CREEKVIEW
EAST PARKING
LOT

SITE PLAN

CASE FILE #PL201800241

GRADING
PLAN

C2-1

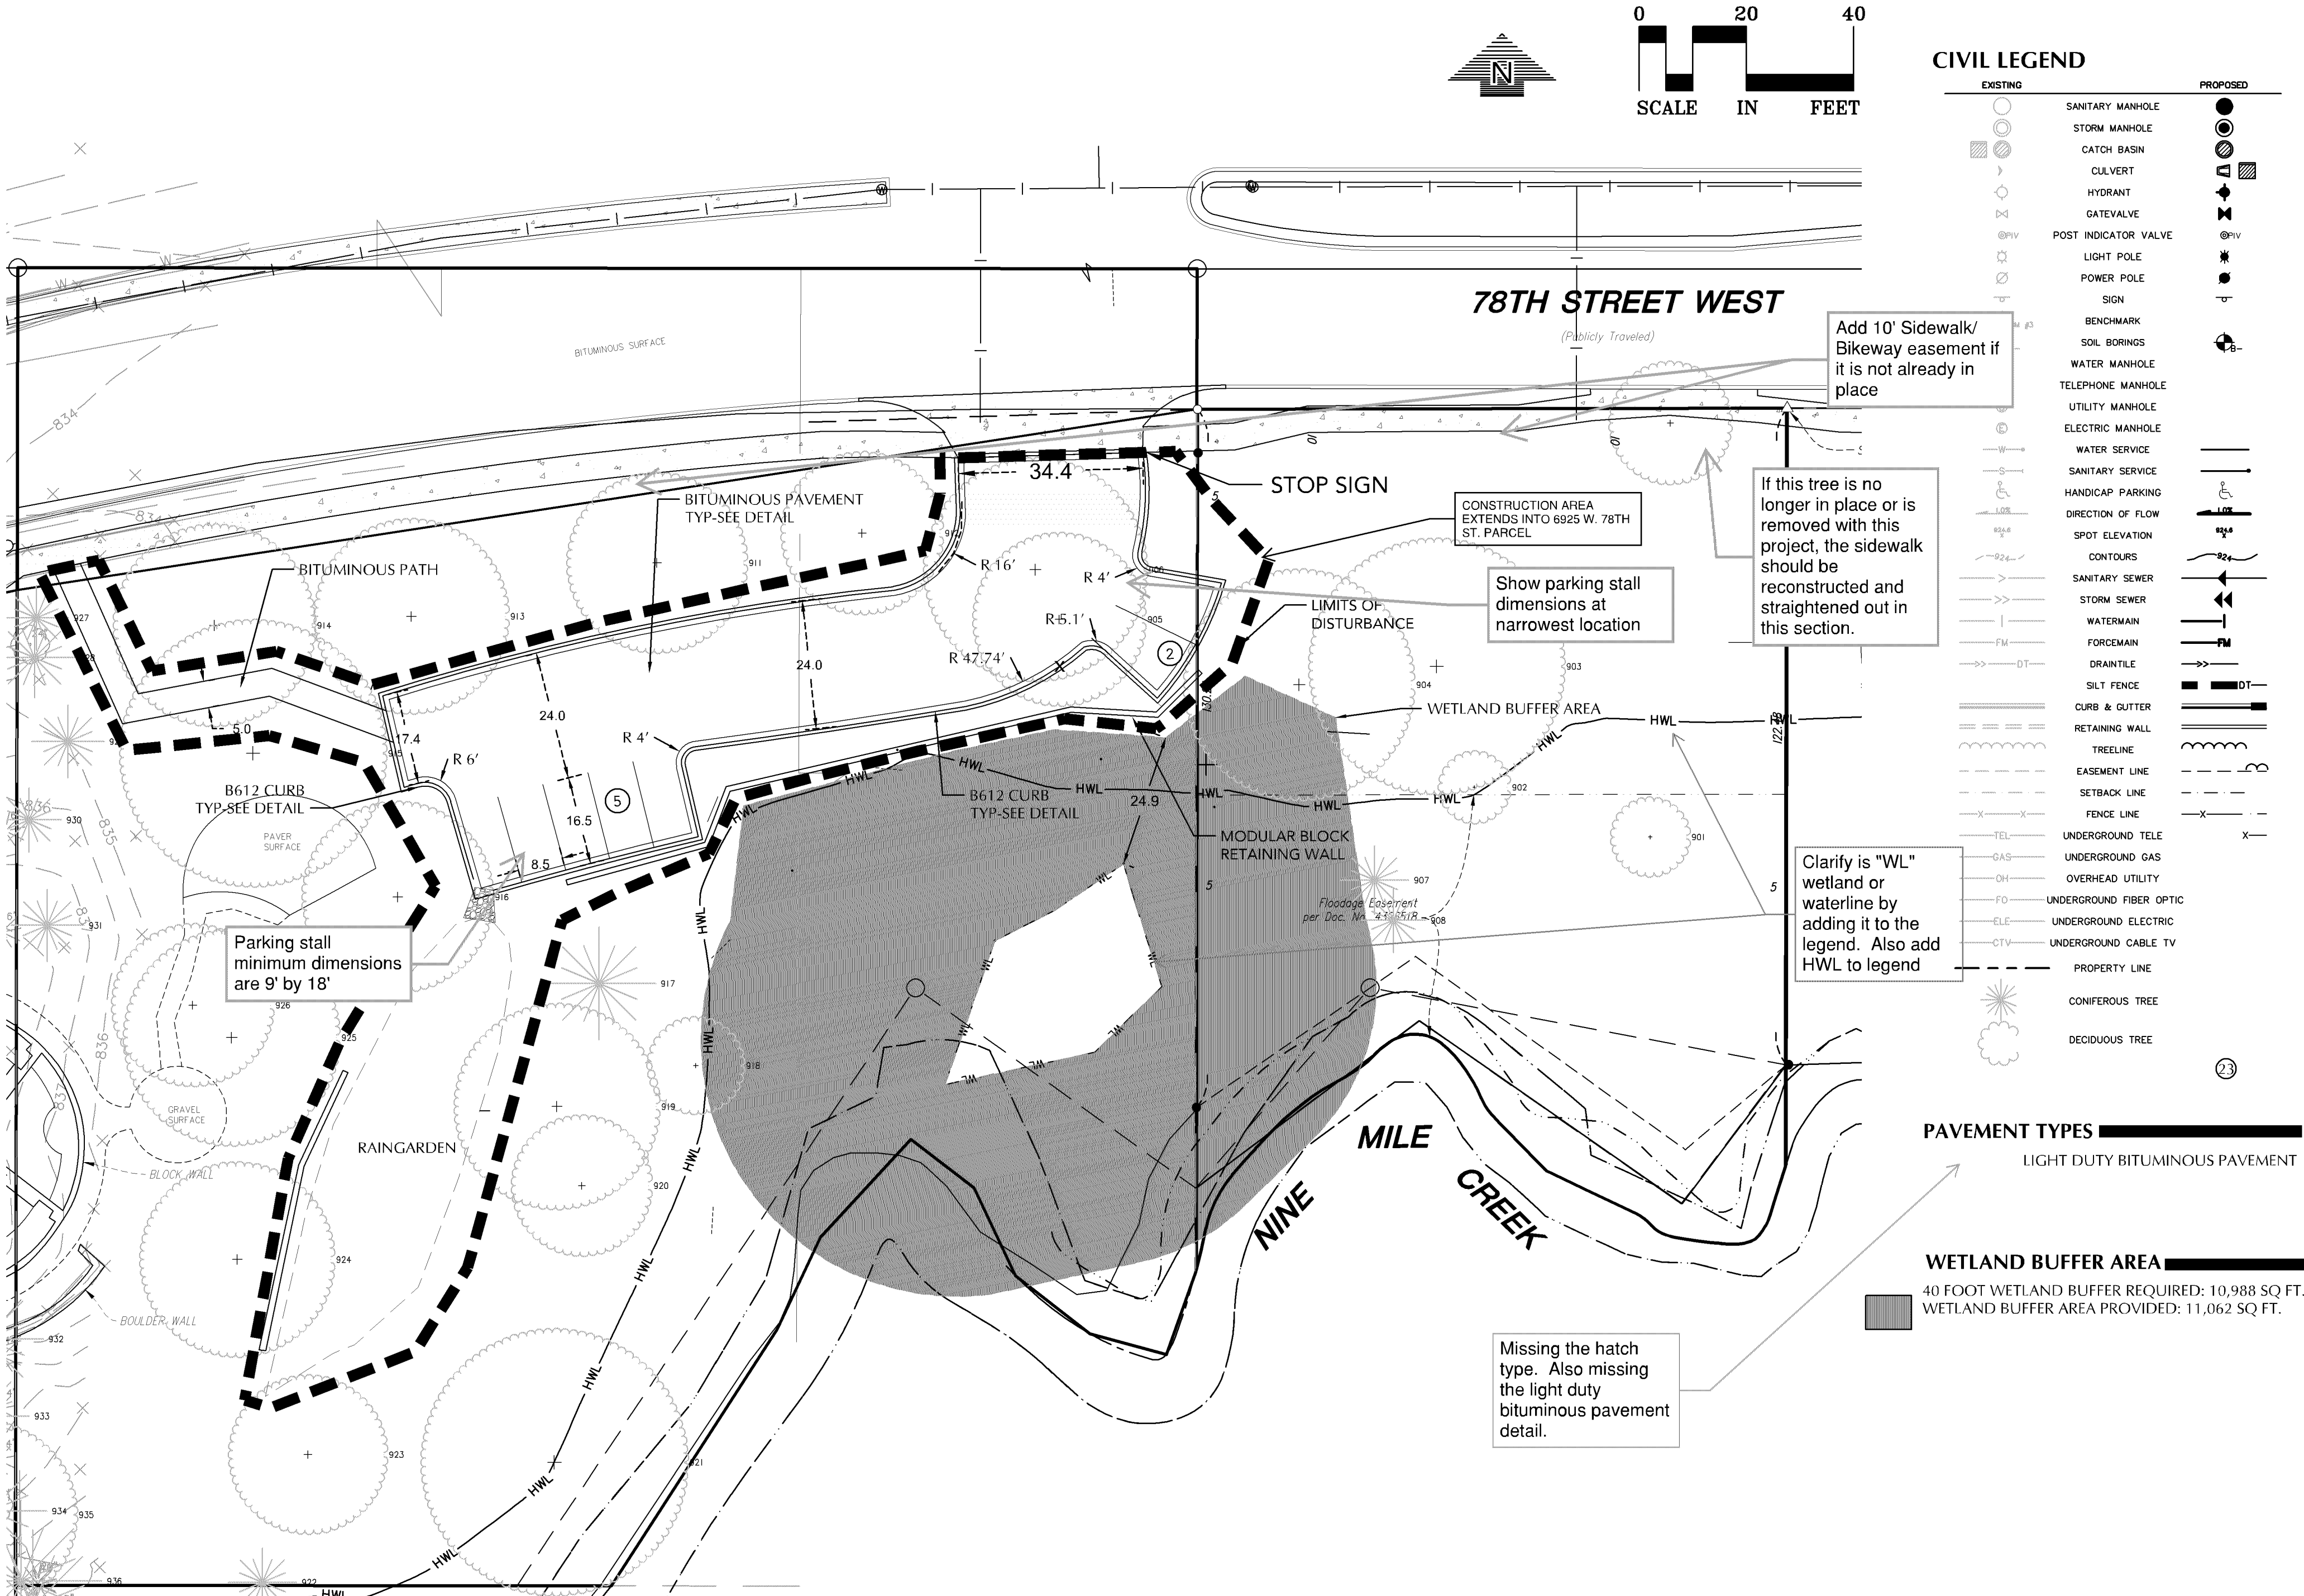
Per Section 21.301.06(c)(2)(C) of the City Code, minimum parking stall size for 90 degree surface parking is 9' x 18'. Compact parking may be allowed per Section 21.301.06(c)(2)(C)(iii).
7. ALL CURB RADII SHALL BE 5.0' UNLESS OTHERWISE NOTED.
8. BITUMINOUS IMPREGNATED FIBER BOARD TO BE PLACED AT FULL DEPTH OF CONCRETE ADJACENT TO EXISTING STRUCTURES AND BEHIND CURB ADJACENT TO DRIVEWAYS AND SIDEWALKS.
9. SEE SITE ELECTRICAL PLAN FOR SITE LIGHTING.
10. ALL PARKING LOT PAVEMENT MARKINGS SHALL BE 4" WIDE WHITE PAINTED STRIPING.

Signs should be placed on the private property and out of the public right-of-way. No sign should be located within the 2' clear zone along the sidewalk.

Maintain emergency vehicle access and circulation throughout the property.

C3-1

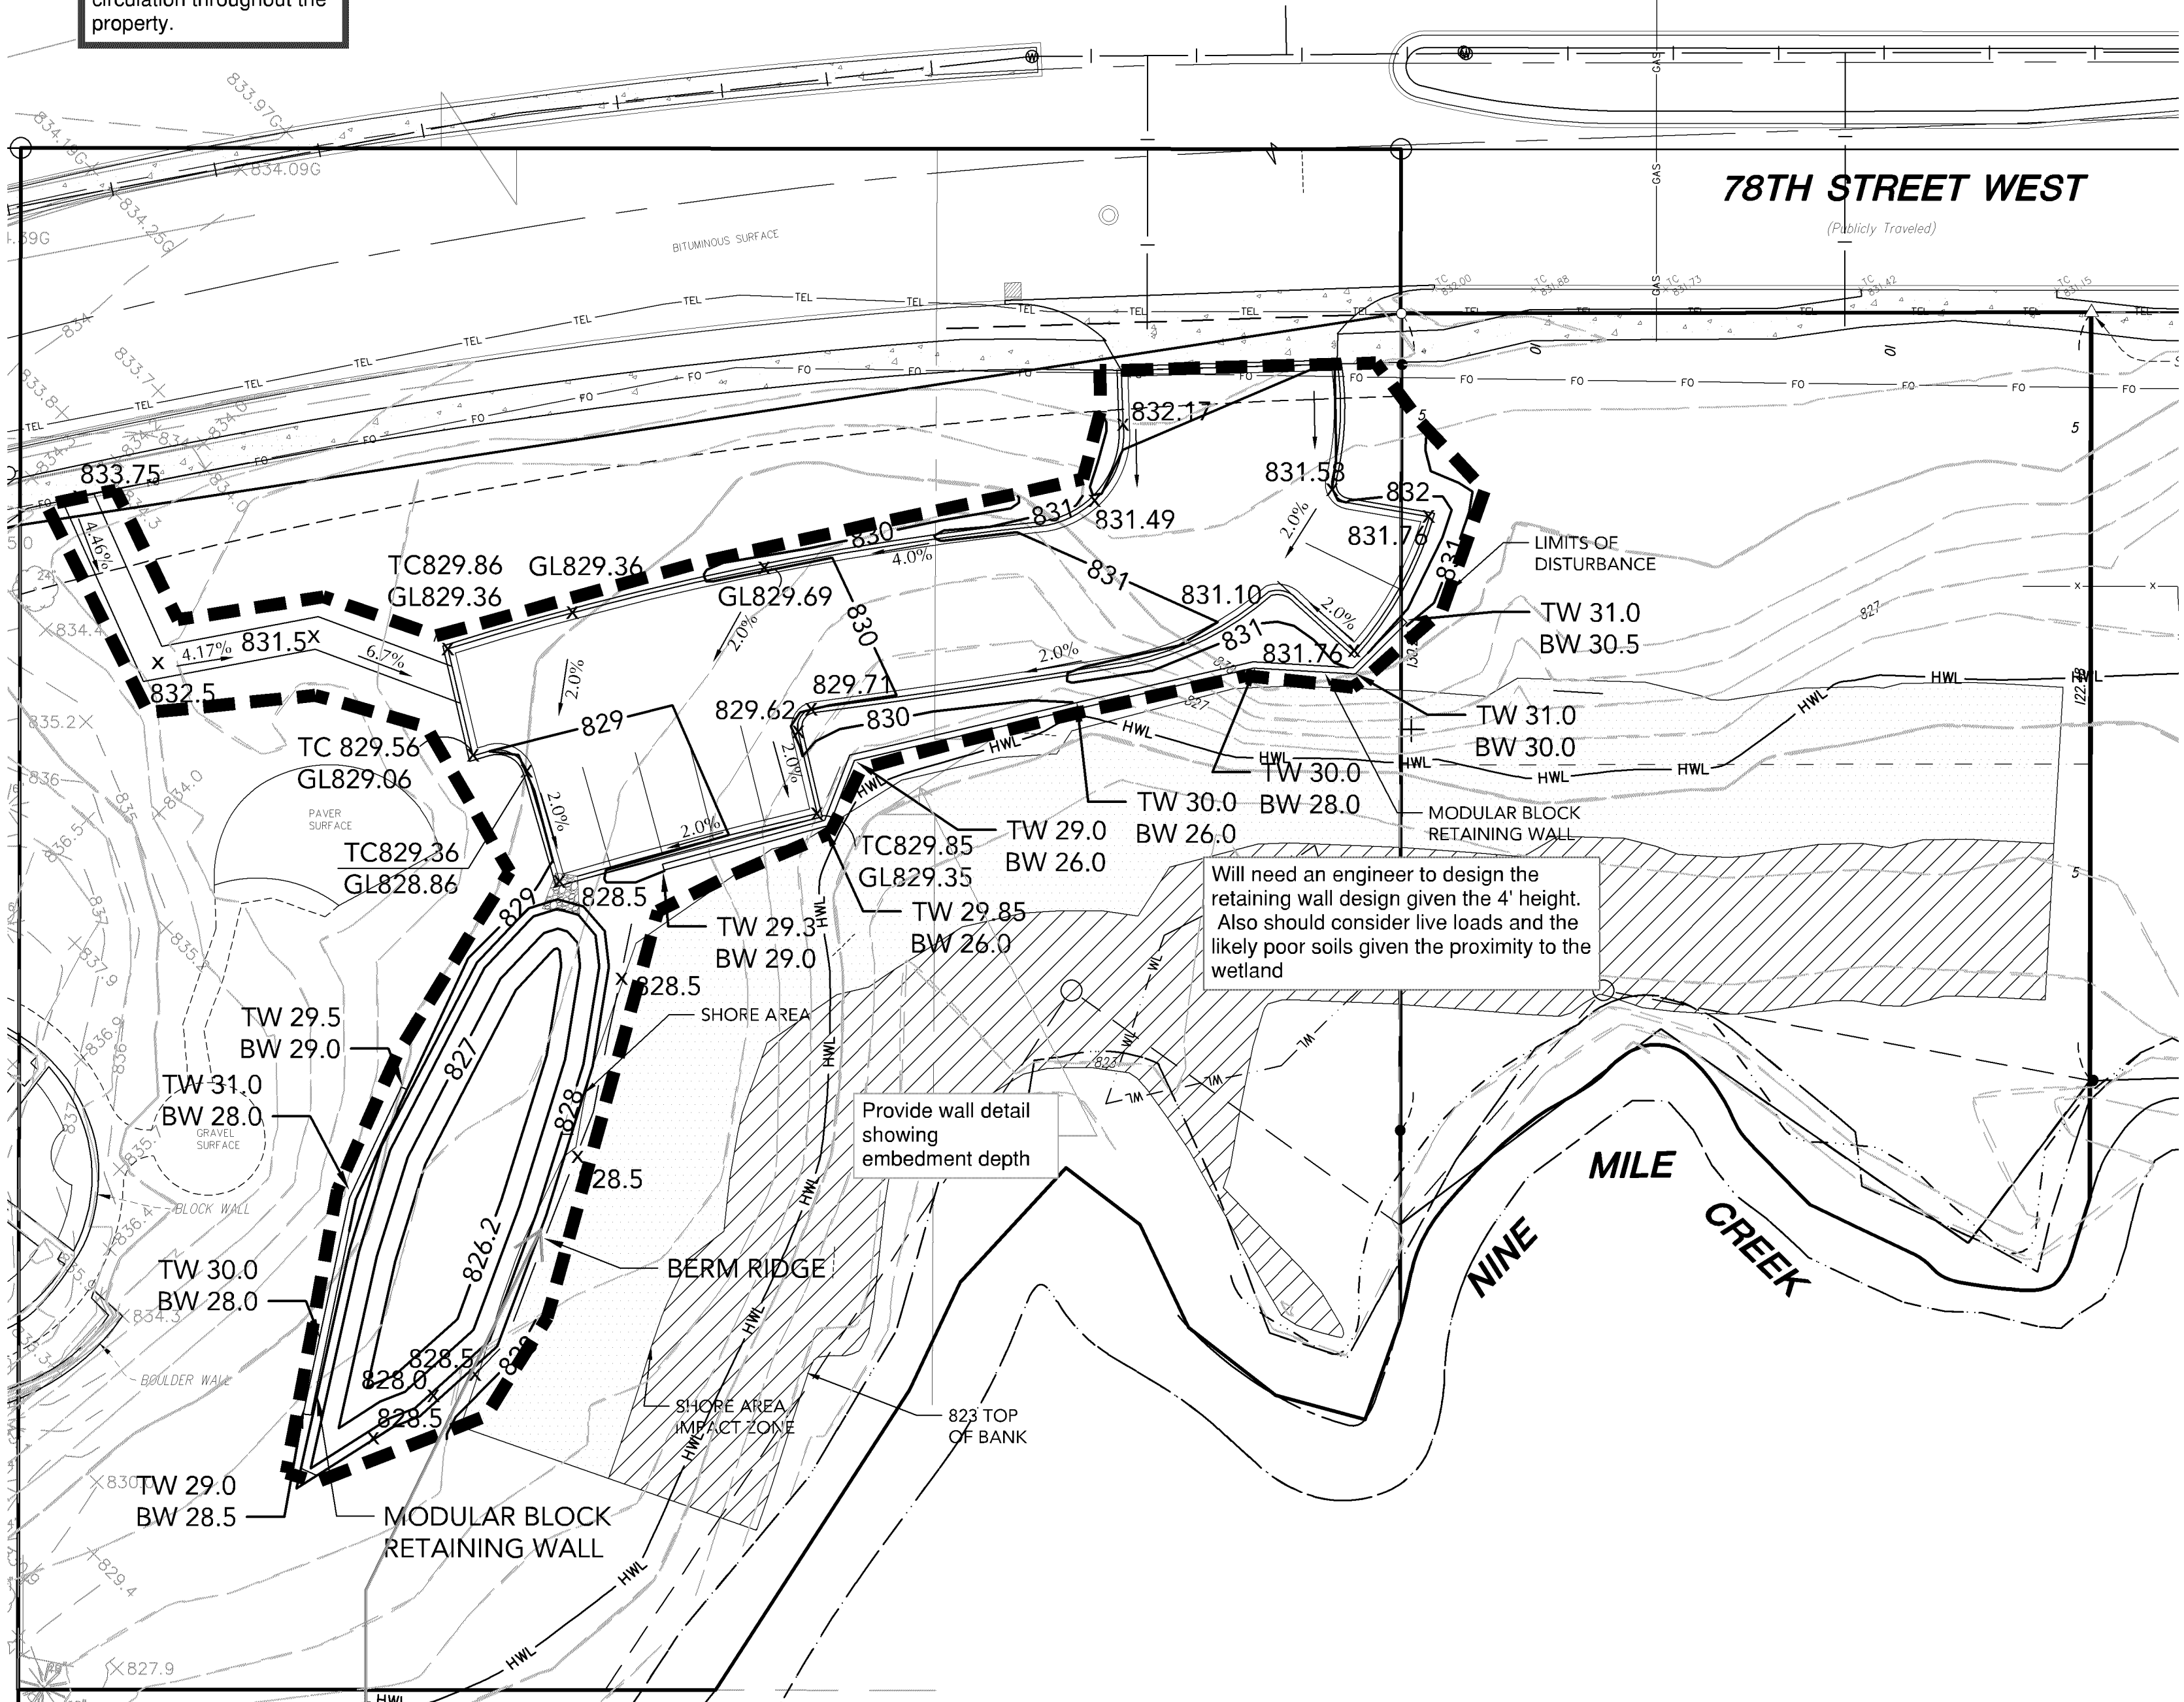
Will need an engineer to design the retaining wall design given the 4' height. Also should consider live loads and the likely poor soils given the proximity to the wetland

Provide wall detail showing embedment depth

Shore Area Permit required for grading within the shore area per Section 19.87.04(b)(2) of the City Code.
